SOUTH CAROLINA ELECTRIC & GAS COMPANY

Subject: Virgil C. Summer Nuclear Station
Docket No. 50/395
Operating License No. NPF-12
Service Water Intake Structure
1983 Diver's Inspection
License Condition 2.C.5

GILBERT COMMONWEALTH ASSOCIATES
Evaluation of Diver Inspection Report dated January 17, 1983
for the V.C. Summer Service Water Intake Tunnel

FIGURE 1
 CRACK SURVEY DATA
 SERVICE WATER INTAKE STRUCTURE
 (UPDATED TO INCLUDE JAN '83 DIVER INSPECTION)

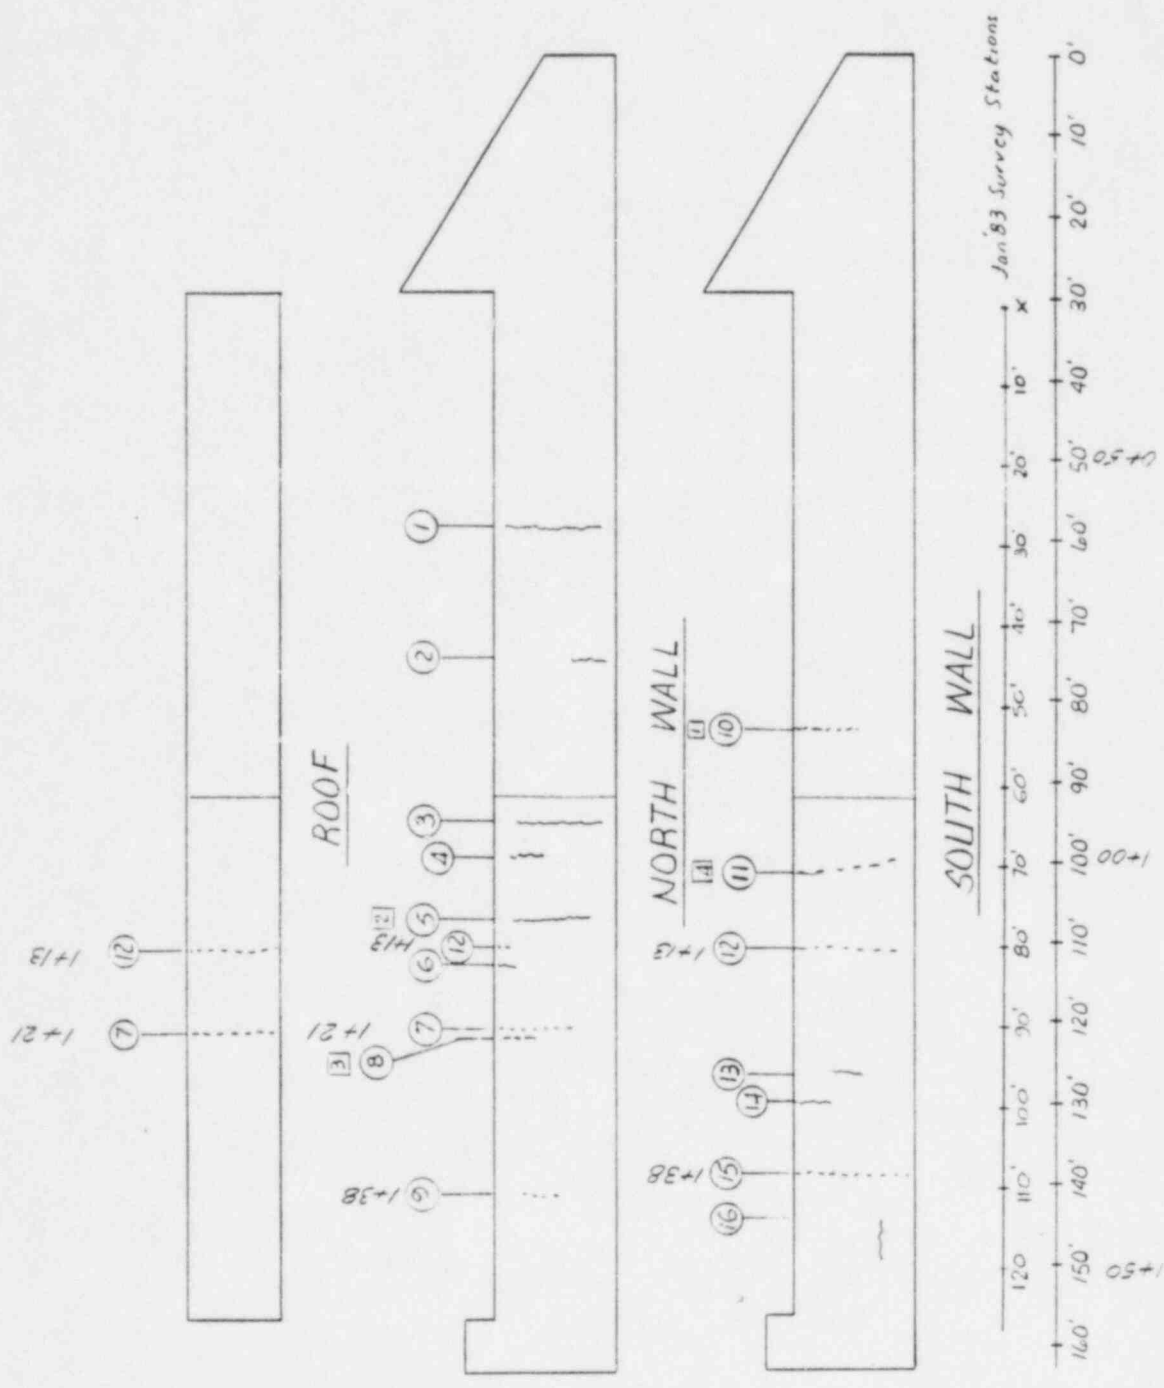
All of the cracks identified were less than 0.015 inch wide. After plotting and comparing with existing crack information (Attached Figure 1) it appears that eight of the sixteen cracks were not previously charted and may be considered new since the 1979 inspection. The direction, location, and size of the cracks do not indicate they have been caused by bending or shear stresses in the structure. These fine cracks will not affect the function or integrity of the structure.

Based on the hairline nature and geometry of the cracks observed, the diver report confirms the results of the external monitoring program that the structure has essentially stabilized and shows no sign of structural degradation.
